C1
Communication
Heritage Vaughan – April 21, 2021
Item # 1

**Re: Heritage Vaughan Committee – April 21, 2021, 2298118 Ontario Inc.
7714 Yonge Street, City File DA.14.009; Reginal File SP-V-016-14**

7714 YONGE STREET
VAUGHAN ONTARIO

Drawing Name
NORTH & SOUTH ELEVATIONS

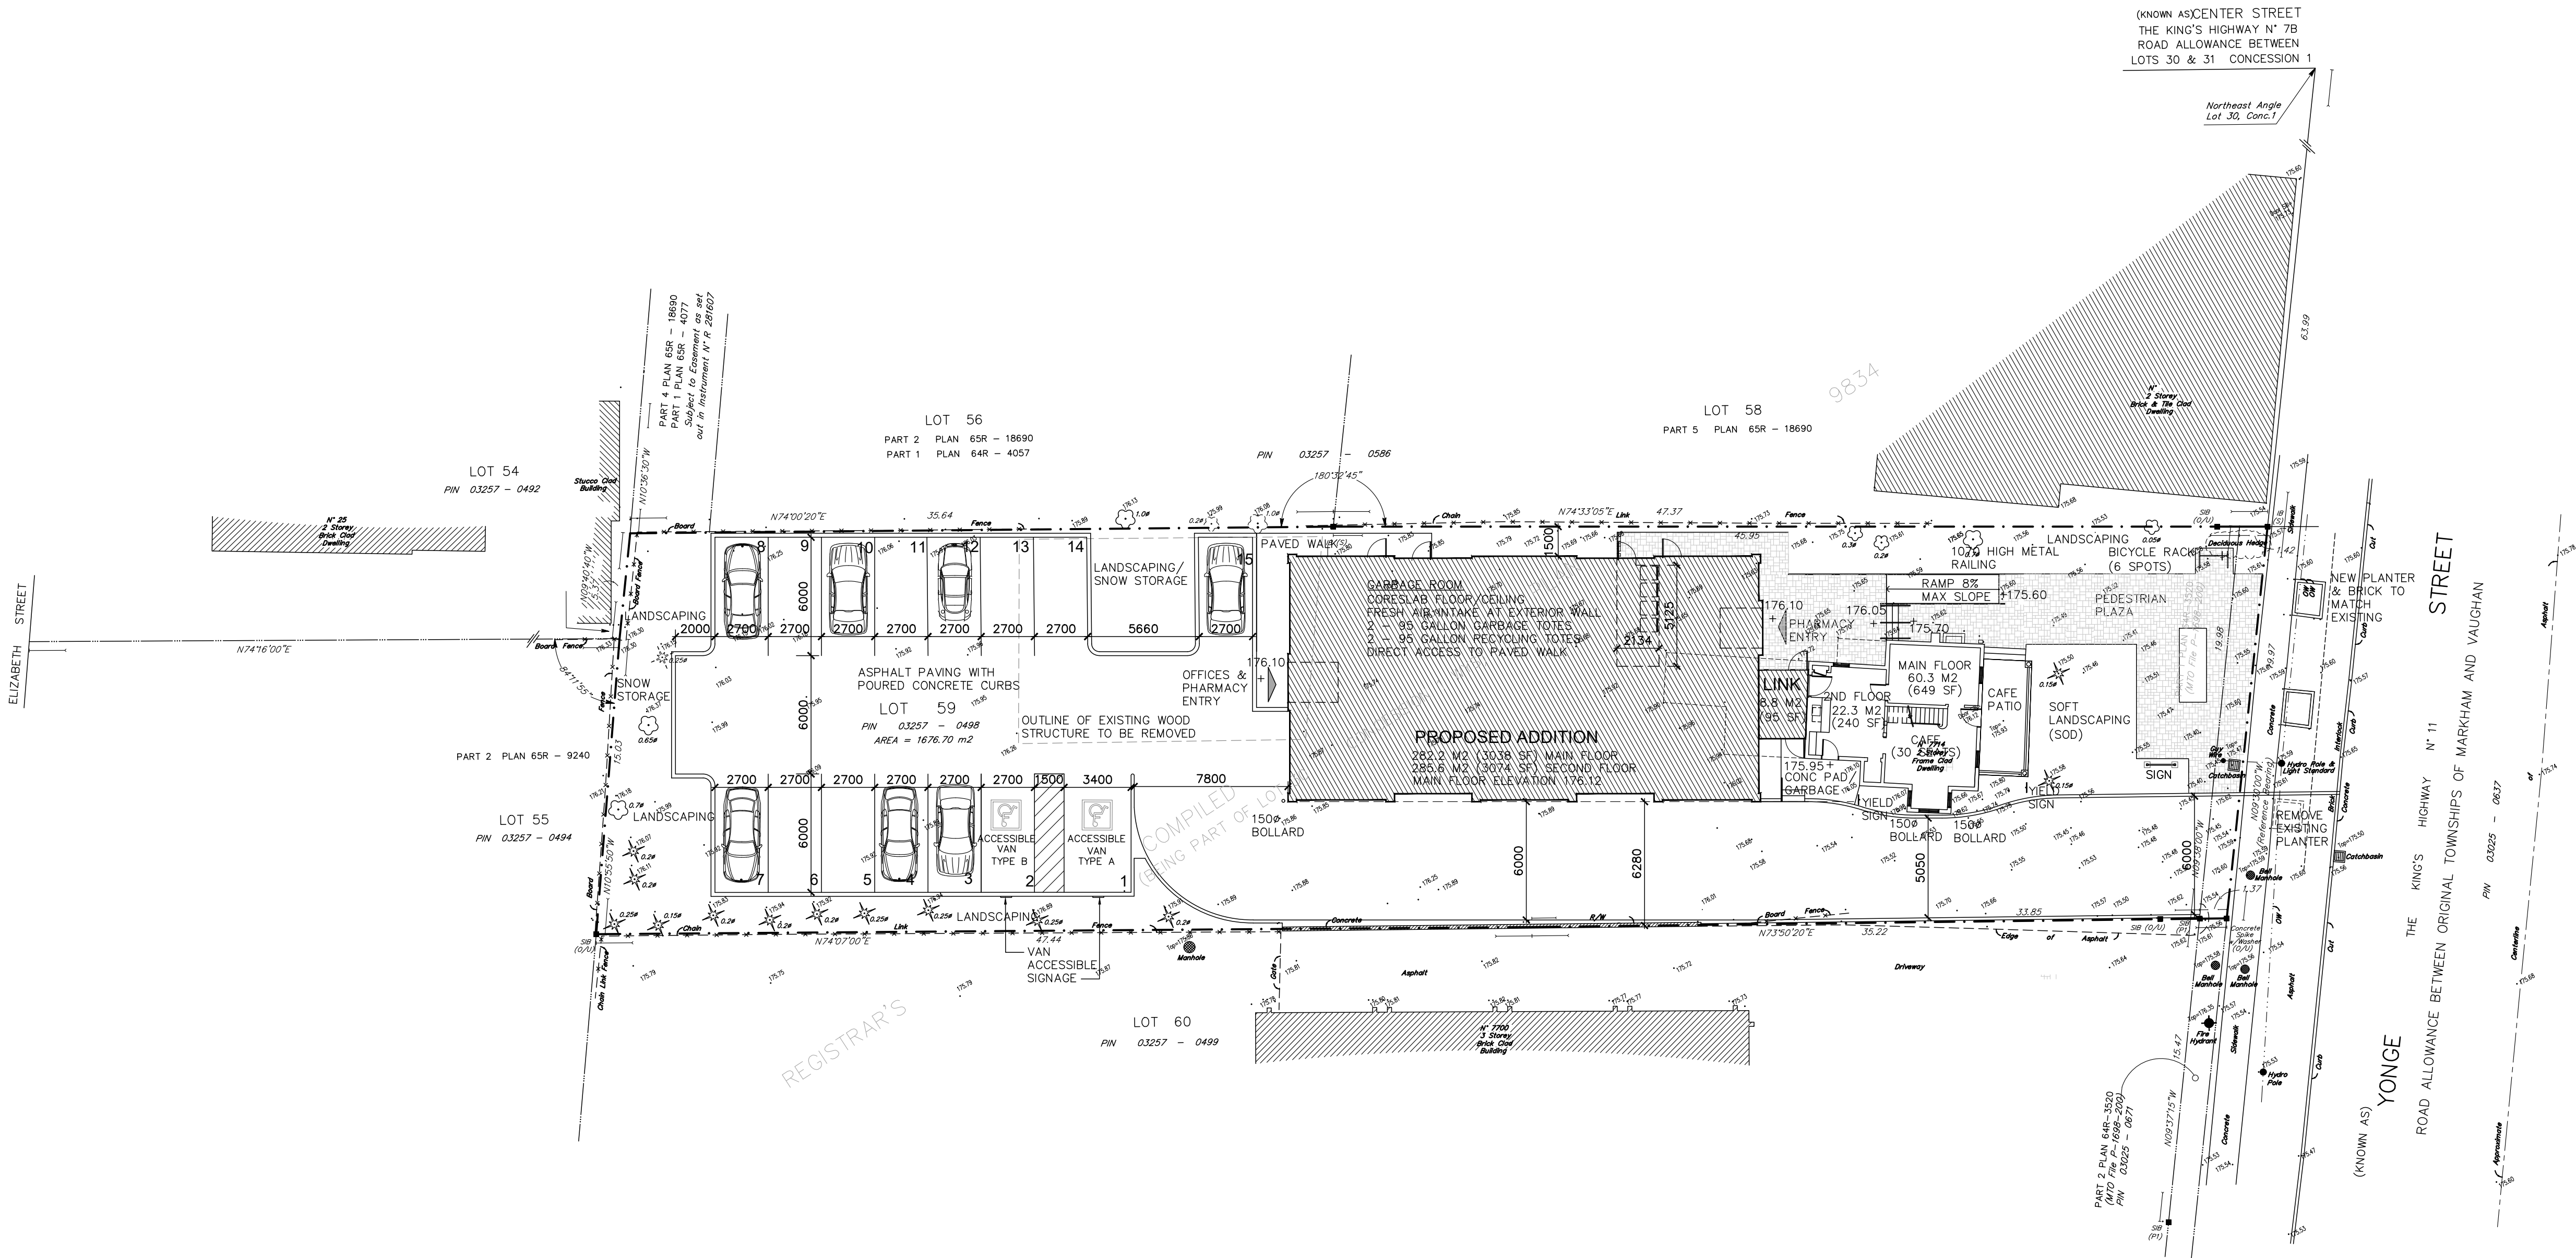
We were also made aware of concerns regarding bird safety as it relates to the proposed one storey breezeway connecting the new construction. In response, we have made notes on the elevation plan that the breezeway is to include bird friendly glass to prevent bird injuries. Similarly, glass railings in the pedestrian plaza have been removed from the plan.

No	Date	Description	By
7	08 APR/21	BIRD FRIENDLY GLASS	BA
6	15 FEB/21	ISSUED FOR SPA	BA
5	12 FEB/21	ISSUED FOR REVIEW	BA
4	08 DEC/20	ISSUED FOR SPA	BA
3	02 MAY/18	ISSUED FOR REVIEW	BA
2	22 JAN/18	ISSUED FOR REVIEW	BA
1	19 OCT/17	ISSUED FOR REVIEW	BA

PRELIMINARY
SITE PLAN

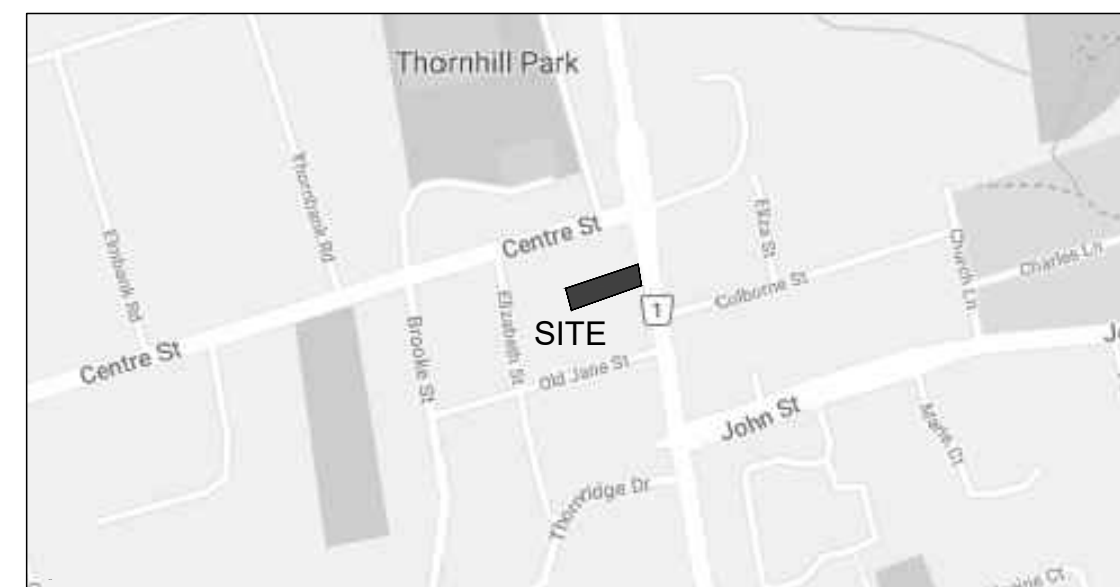
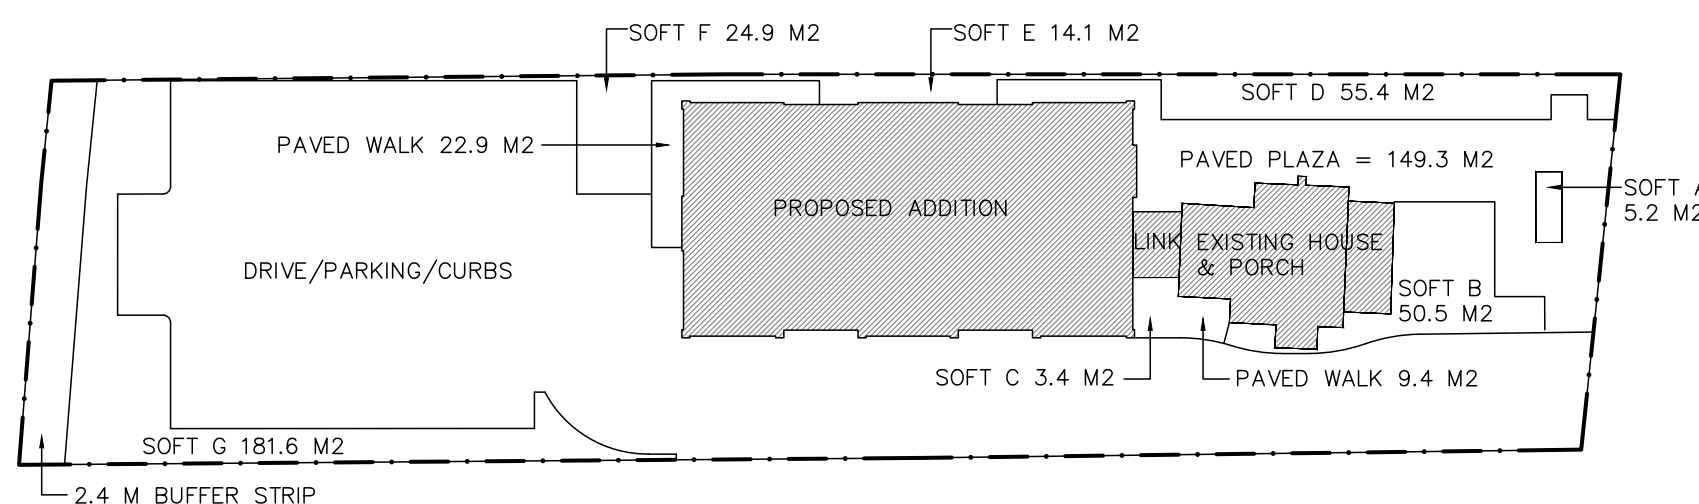
There were also some comments suggesting that the driveway access be shared with the Bell building next door. However, we note that this option was explored early in the process and it was found that the existing grades on the site are such that a shared driveway is not feasible. Further, Bell Canada has previously raised liability issues. As a result, we were not able to provide for a shared driveway with Bell.

We also heard comments related to the amount of hard surface included as part of the proposed pedestrian plaza immediately adjacent to Yonge Street. Again, we wish to point out that significant effort has gone into planning for the creation of a pedestrian area which will enhance the Yonge Street urban fabric while encouraging members of the public to pause and enjoy the streetscape. We note that approximately half of the proposed pedestrian plaza will feature soft landscaping while the remaining area will be interlocked paving to facilitate mobility and access to the building. For clarity, the site plan has been revised to indicate that the landscape area in the front yard is intended to be soft surface. The rendering has also been updated to remove the north fence and more clearly identify the property line between the subject property and the property to the north.

No	Date	Description	By
9	06 APR/21	SNOW STORAGE/RAILING	BA
8	15 FEB/20	ISSUED FOR SPA	BA
7	09 DEC/20	ADDED YIELD SIGNS	BA
6	08 DEC/20	REISSUED FOR SPA	BA
5	11 APR/17	ISSUED FOR SPA	BA
4	17 FEB/17	ISSUED TO CONSULTANTS	BA
3	13 FEB/17	ISSUED FOR REVIEW	BA
2	10 FEB/17	ISSUED FOR REVIEW	BA
1	03 FEB/17	ISSUED FOR REVIEW	BA
